SIGHT LINE ANALYSIS UPDATE

Proposed Townhouse Development
1110 Lorne Park Road
Mississauga, ON

Re: Proposed Townhouse Development, 1110 Lorne Park Road, Mississauga, ON - Sight Line Analysis Update

2. RESPONSES TO CITY UPDATED COMMENTS

Figure 2: Site Plan

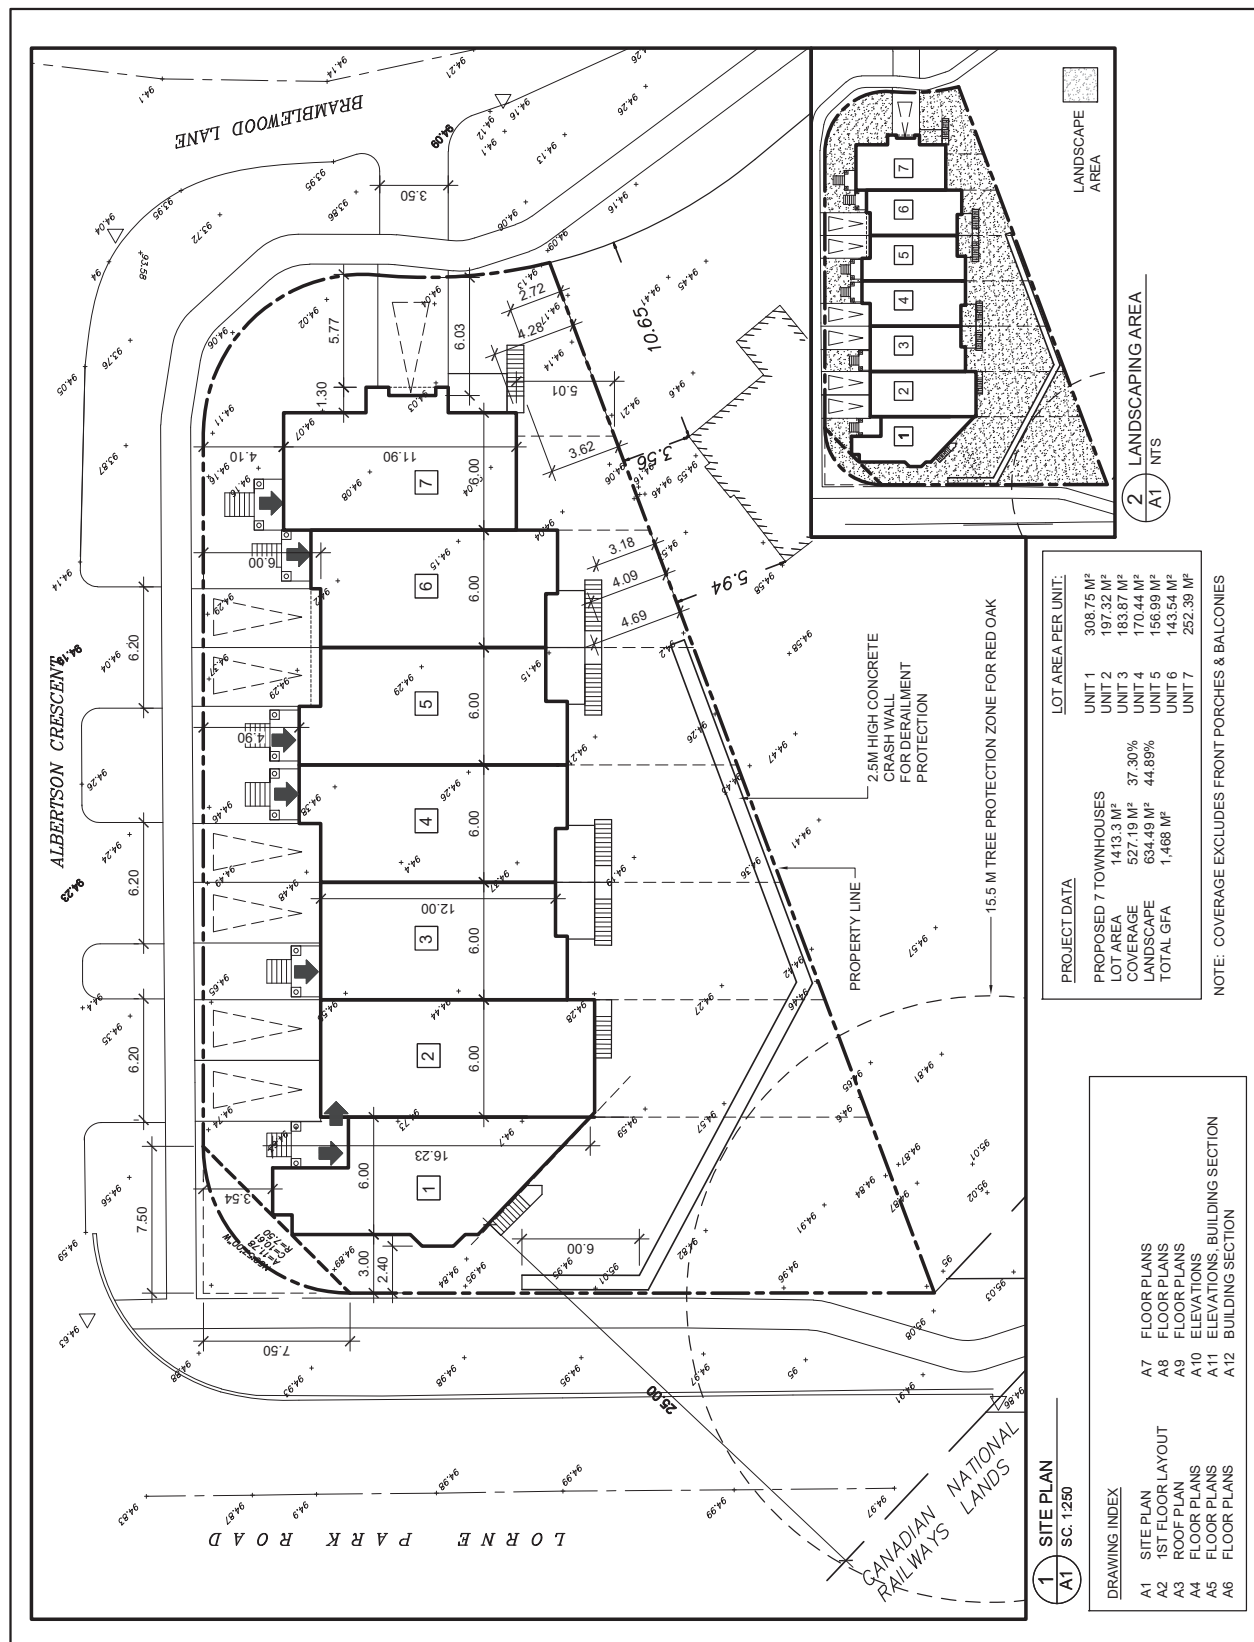
Comment 3: The driveway access for Unit 1/2 does not appear to meet the required corner clearance as per TAC. Please revise.

Table 1 has been updated to include the detailed comparison of required and proposed driveway spacing. The driveway of Unit 1 and 2 is proposed to be 14.7m away from the intersection of Lorne Park Road and Albertson Crescent, including a corner curb radius of 9.1m, a tangent of 4.7m and a driveway curb radius of 0.9m. The tangent separation meets the TAC requirements. The proposed driveway curb radius is less than the minimum requirement of 3m. However, it is expected to serve only 2 vehicles, so the reduced driveway curb radius is considered to be sufficient due to the low volume traffic.

As shown in Figure 2, the proposed 6m crash wall does not encroach within the sight triangle, and driver sightline visibility is maintained. Driver visibility would be impacted if the crash wall were extended any further east on Lorne Park Road other than as shown on the site plan.

Figure 3 - Departure Sight Triangle at Lorne Park Road and Albertson Crescent, Passenger Car

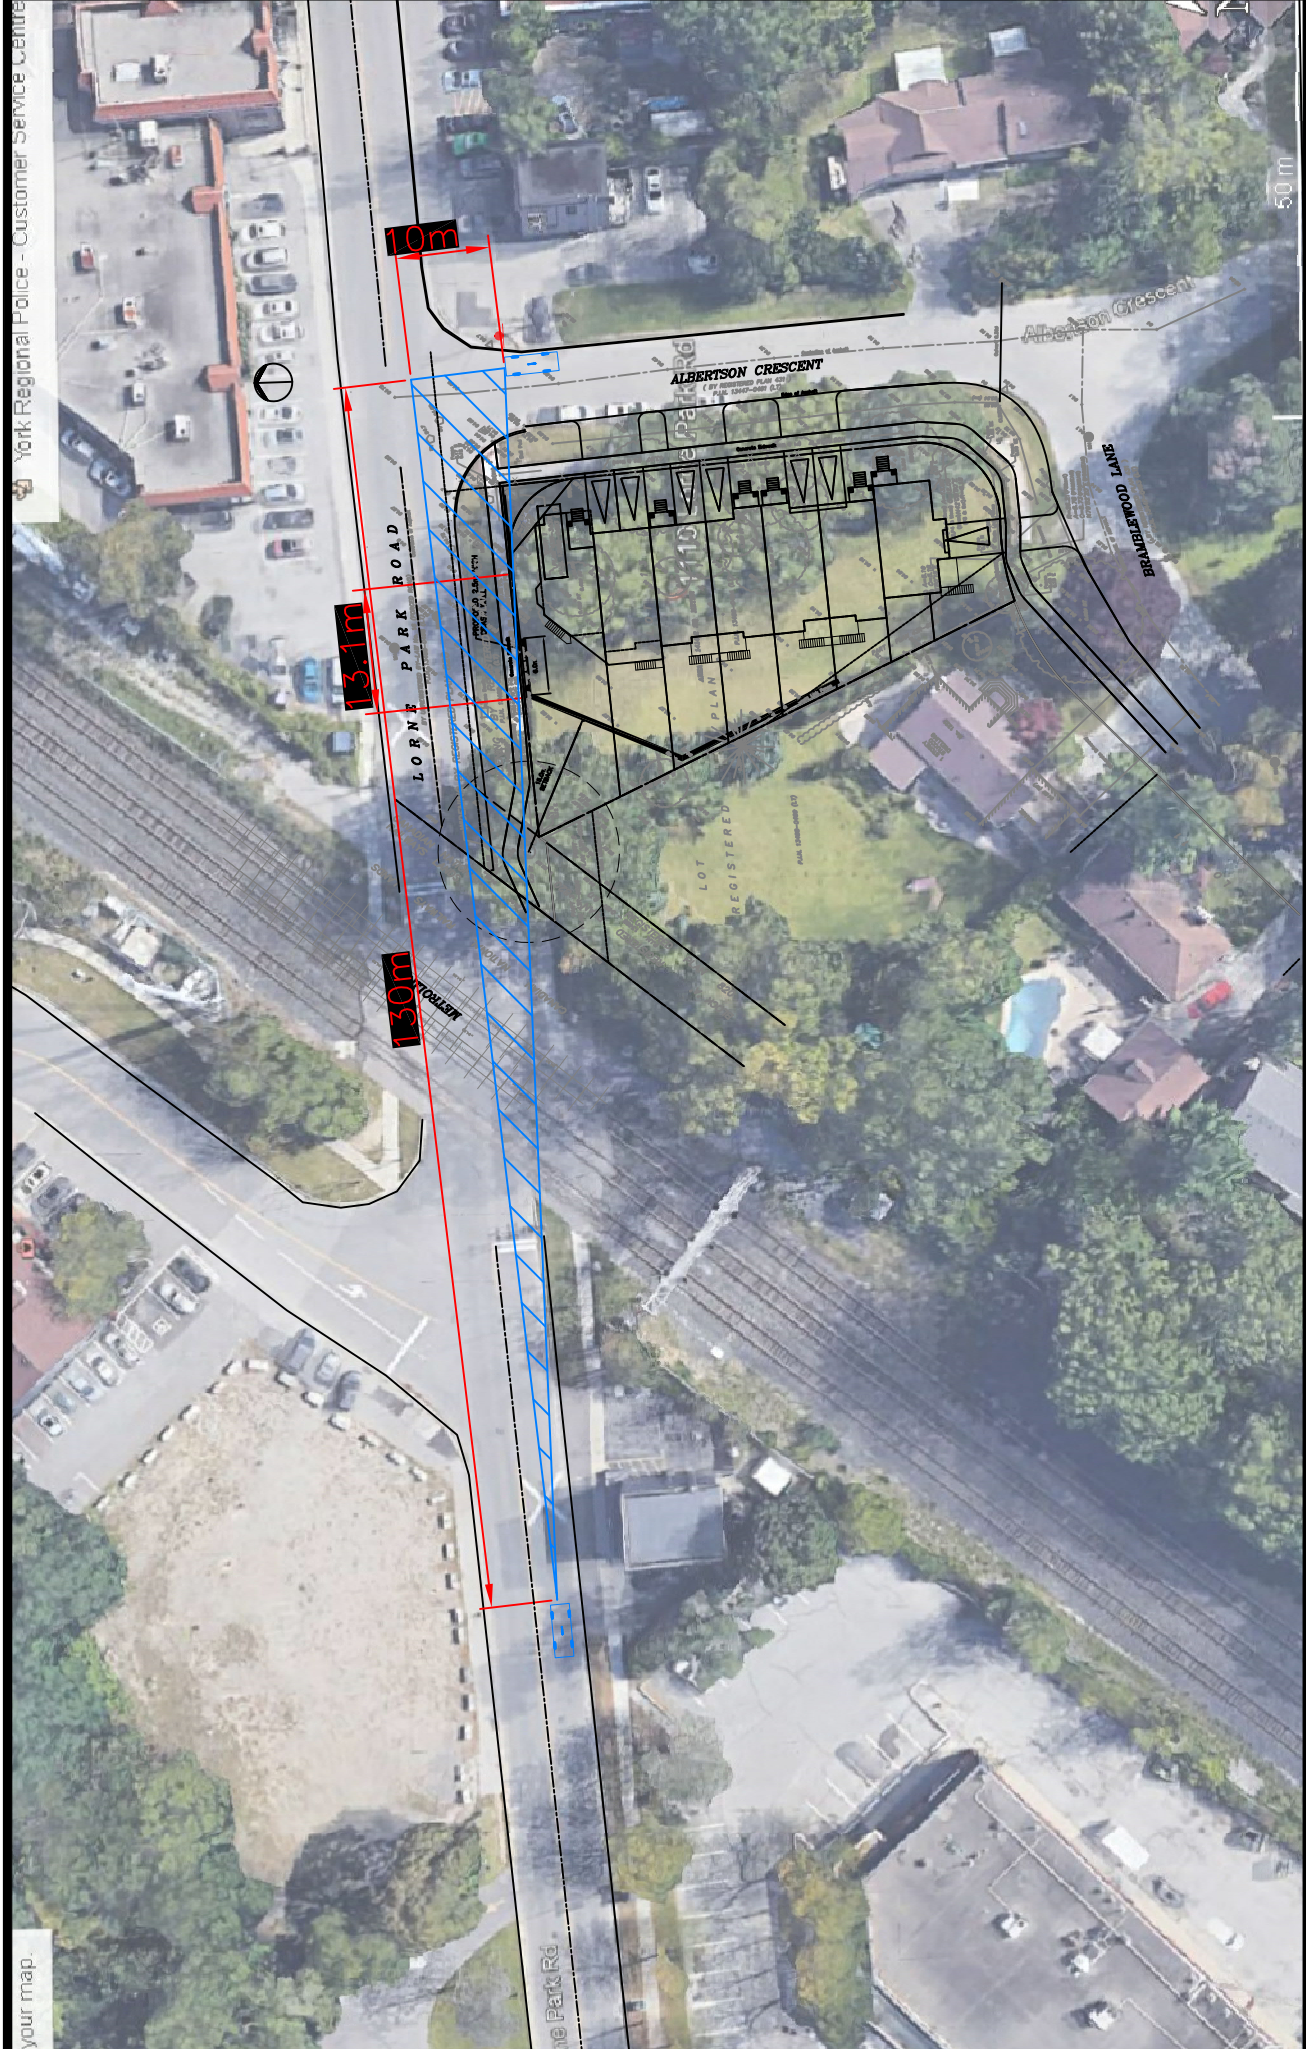
Comment 1: The departure sight triangle provided shall be revised to consider sight lines at the centreline of the southbound travel lane and not the dividing yellow line on Lorne Park Road. The proposed noise/crash wall may be affected as a result.

Based on the crash wall location, our understand of the requirement is to locate the line along Lorne Park Road of sight triangles at the center of the eastbound lane.

As shown in Figure 3 - 4, the departure sight line triangles at Lorne Park Road and Albertson Crescent for both passenger vehicles and Single-unit Truck have been adjusted, and the lines along Lorne Park Road are now located at the centreline of the eastbound travel lane as requested. Table 3 has been updated accordingly.

Figure 9.9.2 from TAC is referred in our review. Distance a_1 is measured by Trans-Plan during field visit, and distance b is design sight distance for the vehicle turning right from Albertson Crescent. A departure sight triangle of passenger vehicle is shown in Figure 3. A design sight distance of 130m was used for passenger vehicle. The clear sight triangle is hatched in red, and no obstructions higher than driver's eye height (approximately 1m) should be located within the area.

Both triangles have been relocated along the centerline of the eastbound travel lane of Lorne Peak Road.

Figure 5 - Departure Sight Triangle at Bramblewood Lane and Albertson Crescent

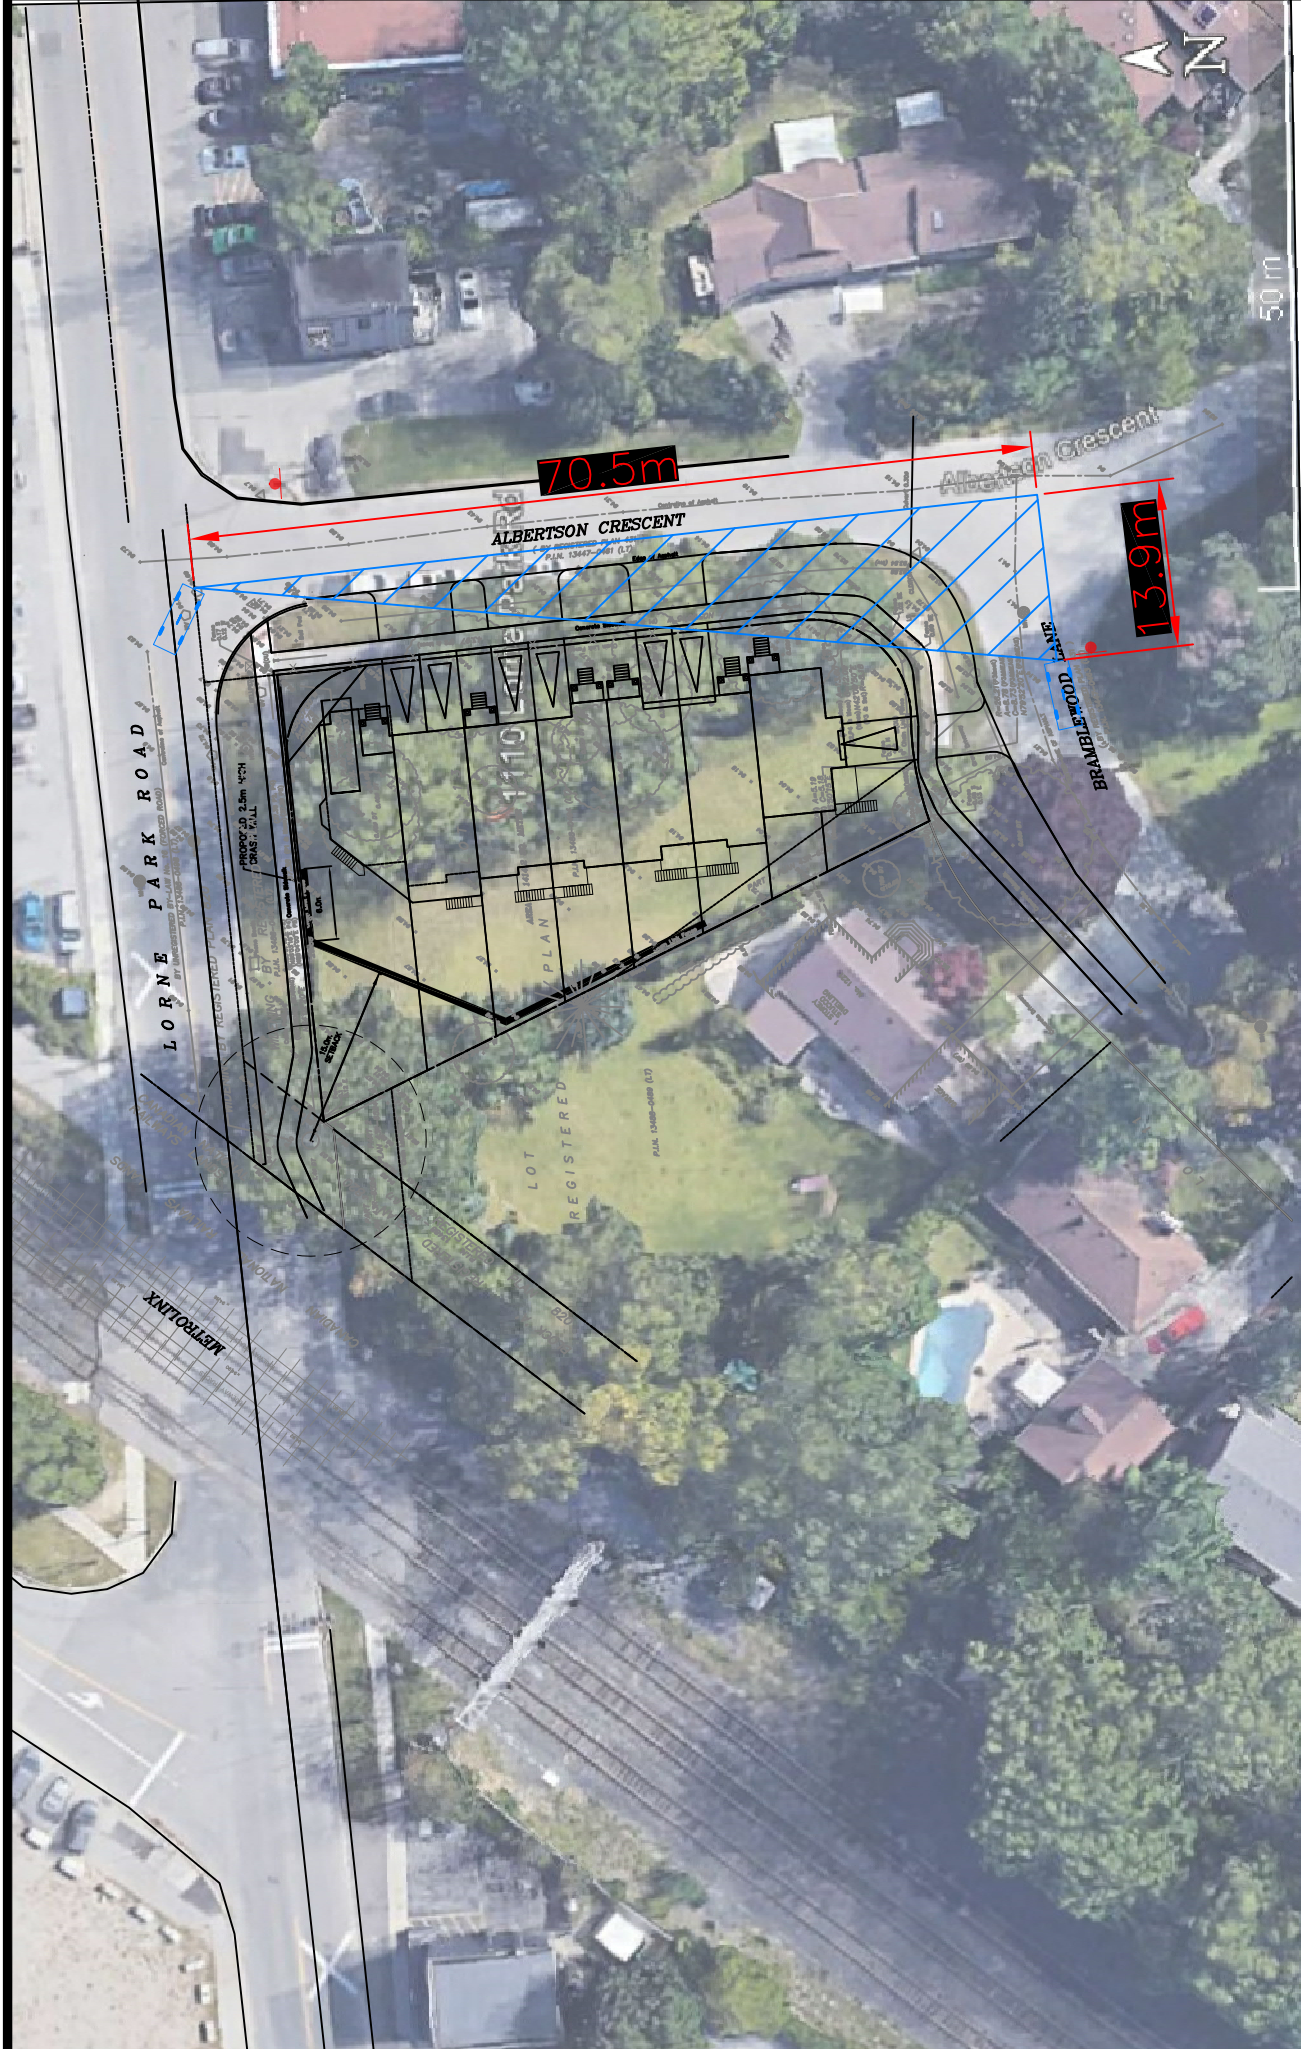
Comment 2: Provide confirmation that there are no sight line conflicts as a result of the proposed building location at Bramblewood Lane / Albertson Crescent.

A departure sight triangle is provided in Figure 5 to demonstrate the proposed building located at the Bramblewood Lane and Albertson Crescent (unit 7) is not expected to reduce the visibility of vehicles exiting from Bramblewood Lane. Details are provided in 6.4 .

Similarly, a departure sight triangle is provided in Figure 5. Distance a_1 is measured by Trans-Plan during field visit, and distance b is 70.5m due to the end of the road. Figure 5 demonstrates the proposed building located at the Bramblewood Lane and Albertson Crescent (unit 7) is not expected to reduce the visibility of vehicles exiting from Bramblewood Lane.
